Subject ▶ Change on fan 90

For Models ▶ BO5000 and BO5000KDA (Random Orbit Sander)

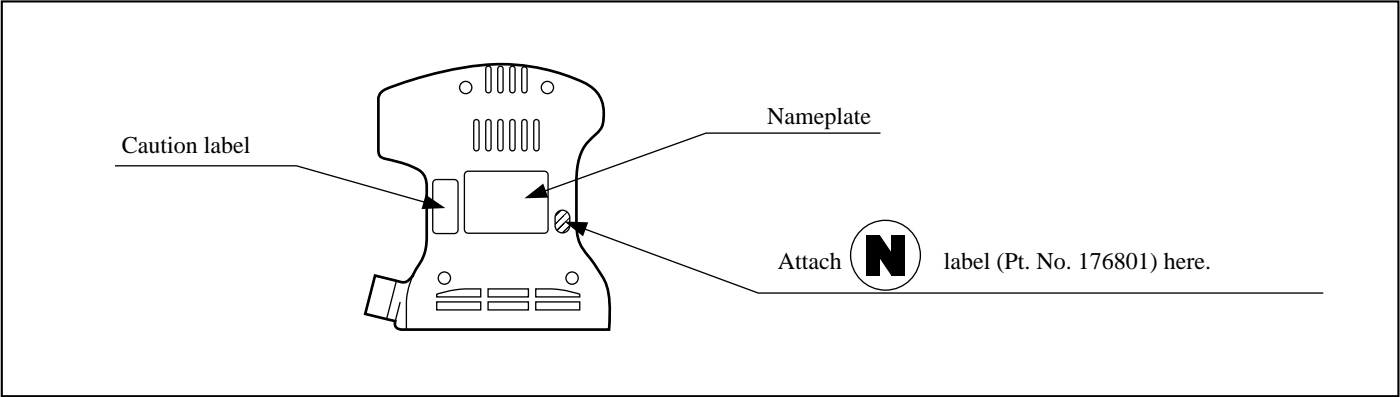
Description ▶ The fan 90 will be changed as follows.

▶ Current (Material: Zinc alloy)	▶ New (Material: Aluminum alloy)
<p>Balance weight</p> <p>Thickness: 2.3 mm (3/32")</p>	<p>Balance weight</p> <p>Thickness: 3.8 mm (5/32")</p>

Item No.	Current part		Q'ty	I/C	New part		Q'ty	Note
14	Fan 90 241655-4			<=	Fan 90 241659-6

Interchangeability mark : <= mark indicates that the new type part can be substituted for the current type part.

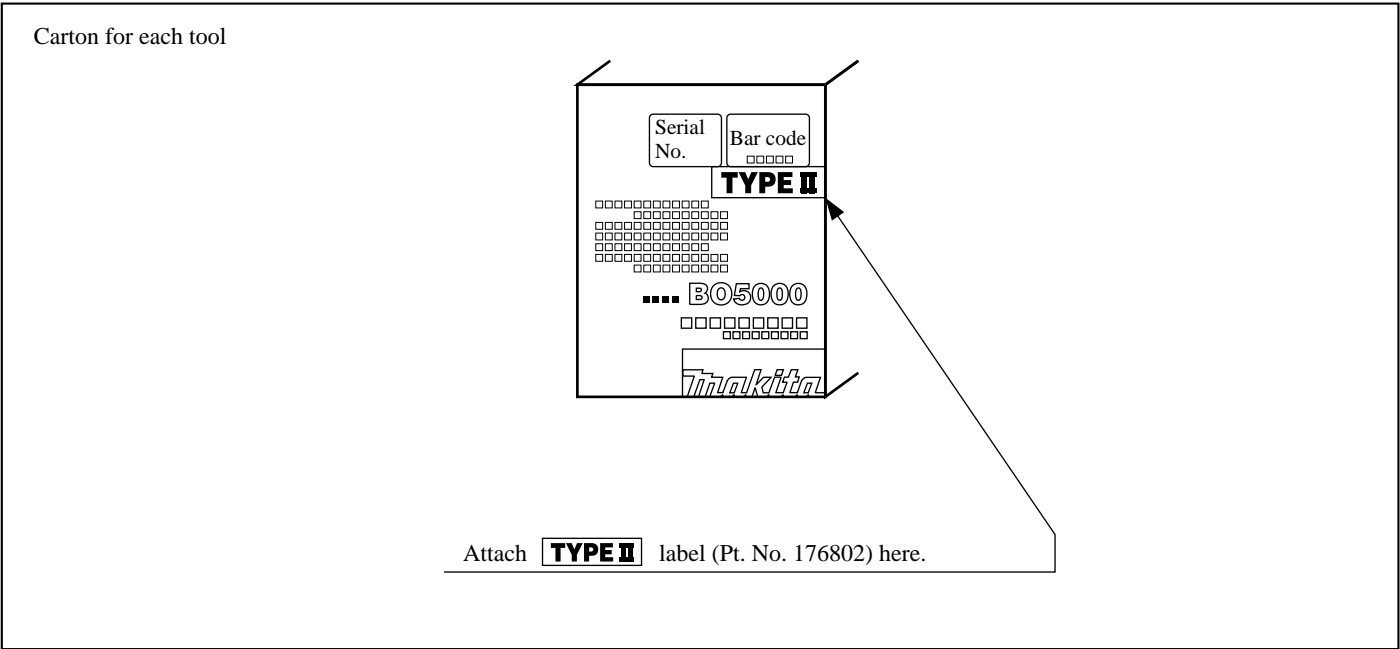
The current type fan 9 employed in all Models BO5000 and BO5000KDA which you sold to your customers or you have in your stock should be replaced by the new type fan 9. After replacing the fan 9, attach the following labels to tools, cartons for each tool and master cartons.
